Addendum to the
Environmental Impact
Assessment Report

NISA
North Irish Sea Array

Chapter 30

Noise and Vibration

Image A30.4 Graph showing measured noise level at NM8, threshold of hearing, and predicted noise level at LAP2 for the 63Hz octave band

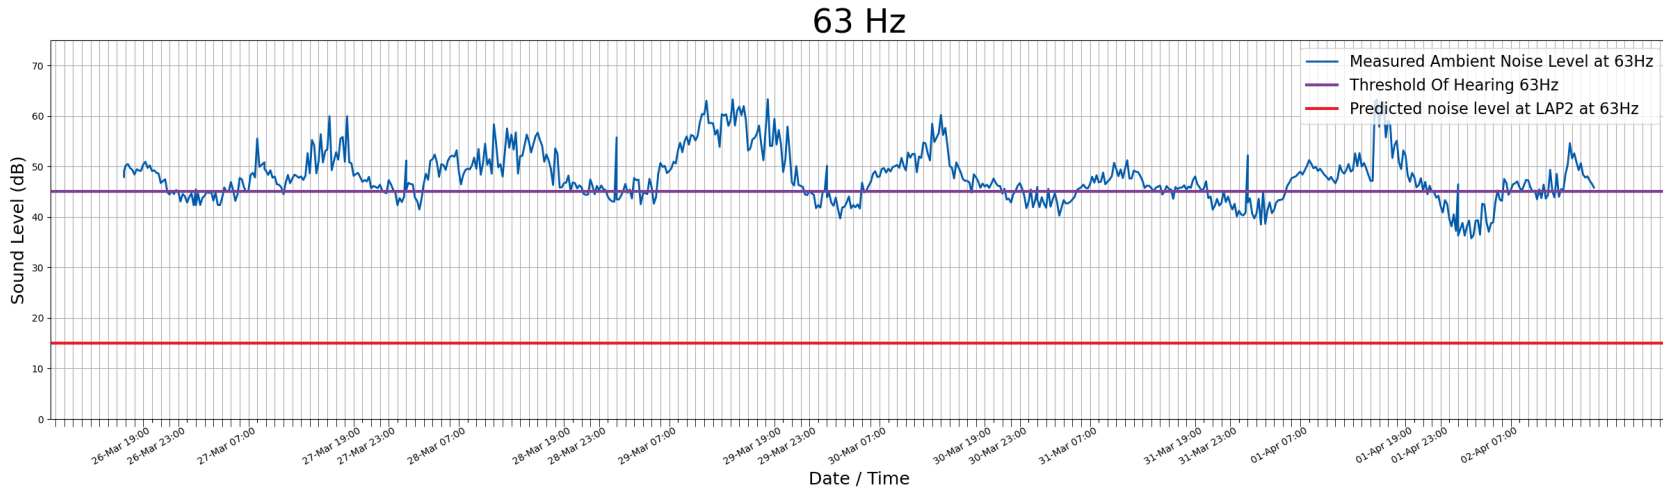
As can be seen from the graphs, the predicted overall noise at the LAP is below both the measured noise level on site, as well as the threshold of hearing. Providing that the equipment selected for the grid facility has noise levels that are equal to or less than the octave band data provided in Table A30.11, no impact from tonal or low frequency noise is predicted.

It is acknowledged that transformers can have a peak in 100Hz frequency; however, analysis at 100Hz with 1/3 octave band data has not been completed as the data is not available given the exact models and manufacturers of the equipment is not known at this stage in the design. Once detailed design is completed this will be assessed and any exceedances will be appropriately mitigated. The assessment outcome is unlikely to change as the results above show the predicted noise levels are well below the threshold of hearing at low frequencies. As an additional precaution, the 5 dBA tonality correction has been added to the predicted broadband noise levels in Table A30.12 to Table A30.14 above.
